S E R V I C E N O T E

E1610A 34 Mb/s E3 Line Interface for Broadband Series**Serial Numbers:** AU00000000 / AU99999999 (All Serial Numbers)**Required modifications not completed on exchange parts.****To Be Performed By:** Agilent-Qualified Personnel**Parts Required:**

E1610A E3 34 Mb/s LIF Modifications**Figure 1**

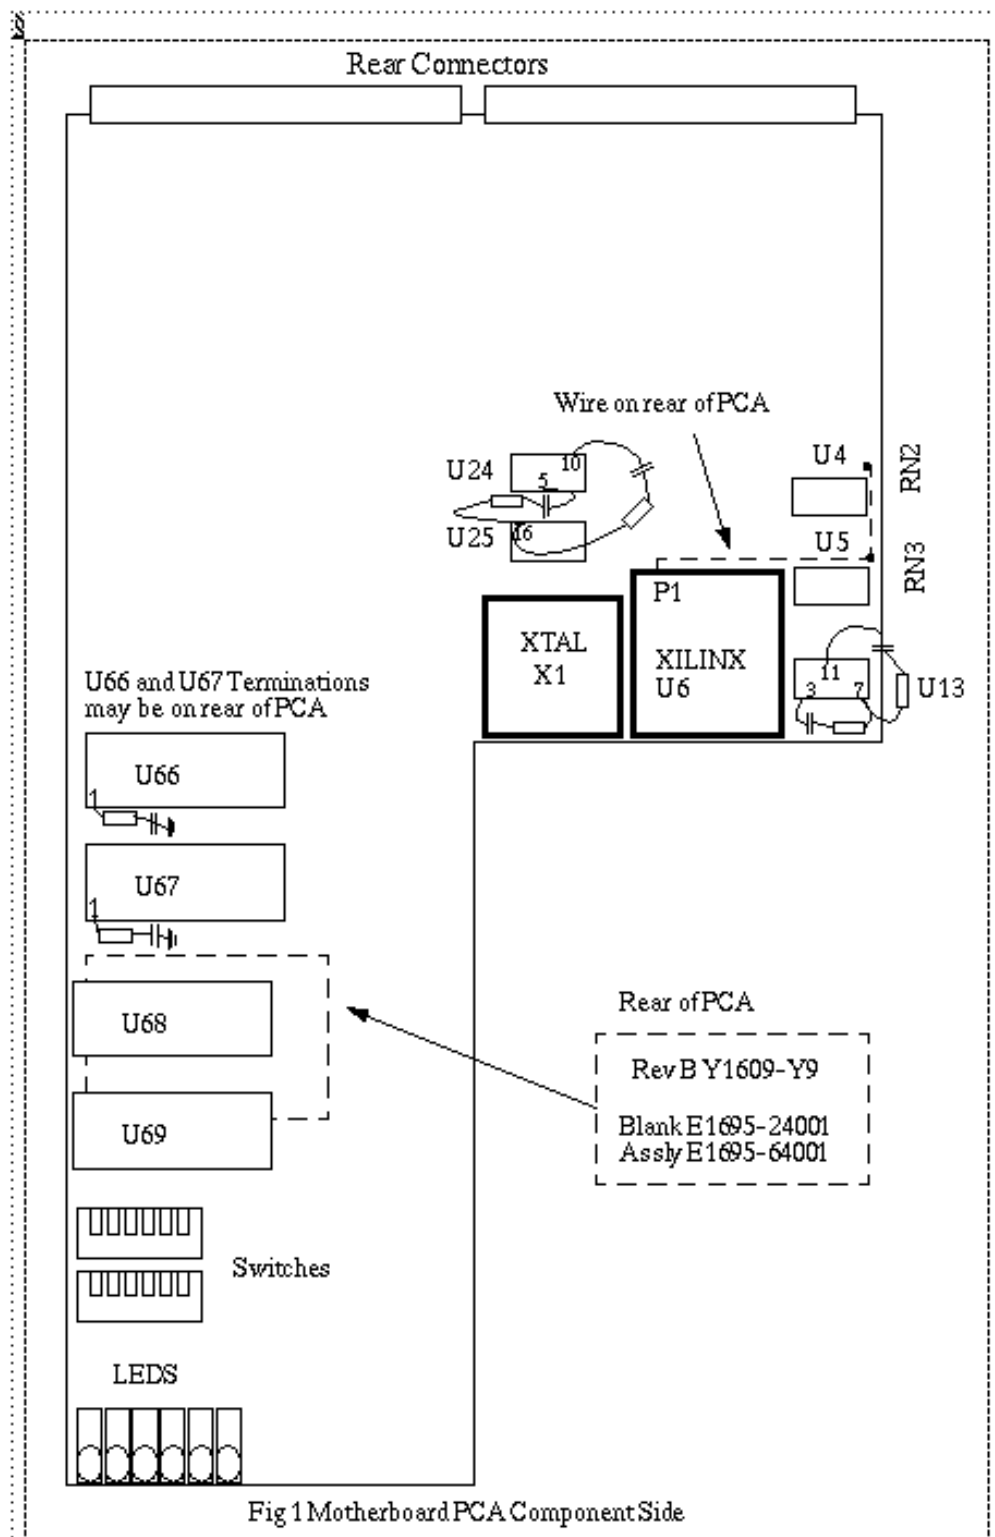
If the version of the motherboard is Rev B, then the following modifications should be apparent (See Fig 1 also).

- 51R1 Resistor and 1nf Capacitor from Pin 1 of U66 to ground.
- 51R1 Resistor and 1nf Capacitor from Pin 1 of U67 to ground.
- Wire link on rear of PCA between pin P1 of U6 and Pin 9 (lifted) of U5 then to pin 9 of U4 (lifted).
- 51R1 Resistor and 1nf Capacitor in series from U13 pin 3 to U13 pin7.
- 51R1 Resistor and 1nf Capacitor in series from U13 pin 11 to U13 pin7.
- 82R5 Resistor and 1nf Capacitor in series from U24 pin 5 to U25 pin 16.
- 82R5 Resistor and 1nf Capacitor in series from U24 pin 10 to U25 pin16

If all of the above modifications have not been done, please return the complete, reassembled module, with an accompanying note attached to the module, identifying it as "For modification as per Service Note E1610-02".
